INSTRUCTION SHEET

TOUCH PANEL INDICATOR LIGHTS AND BUTTON OPERATING PROCEDURES

OLDER PANEL

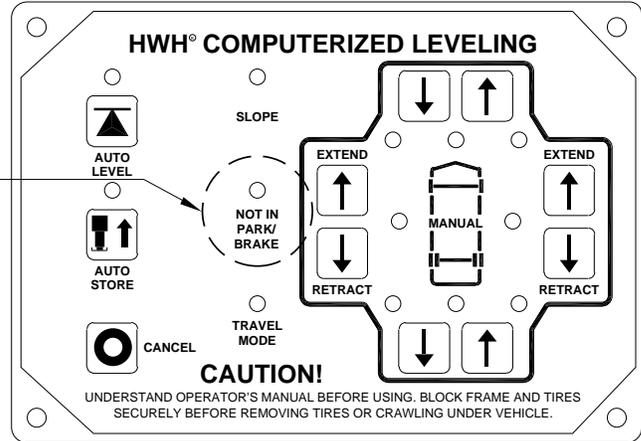
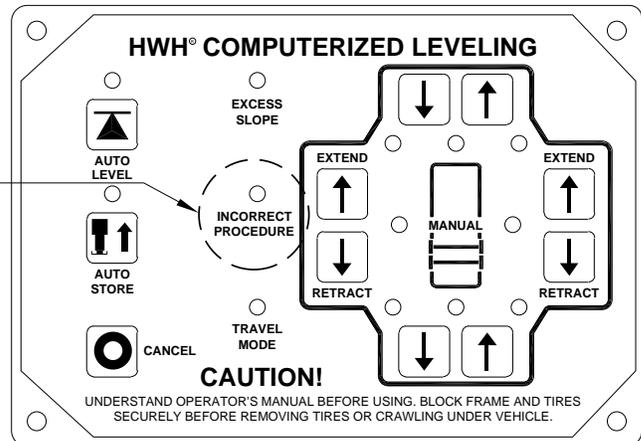
Check the existing touch panel. If the "INCORRECT PROCEDURE" light is labeled "NOT IN PARK/BRAKE" on the existing touch panel, it is important that the owner receives this sheet.

If the existing touch panel has a "NOT IN PARK/BRAKE" light, the existing control box being replaced may have a slightly different program.

The program in the replacement control box uses the "NOT IN PARK/BRAKE" LIGHT (older panel) or the "INCORRECT PROCEDURE" light (current panel) to indicate a procedure issue that will not allow the system to auto level or auto store the leveling system.

If the system is equipped with the older style touch panel it is NOT necessary to change the touch panel, but if desired, a new lexan can be ordered. The part number for the new lexan is RP92639. To replace the lexan, simply use a small knife to peel the old lexan off of the touch panel. Remove the protective back from the new lexan and press the new lexan in place.
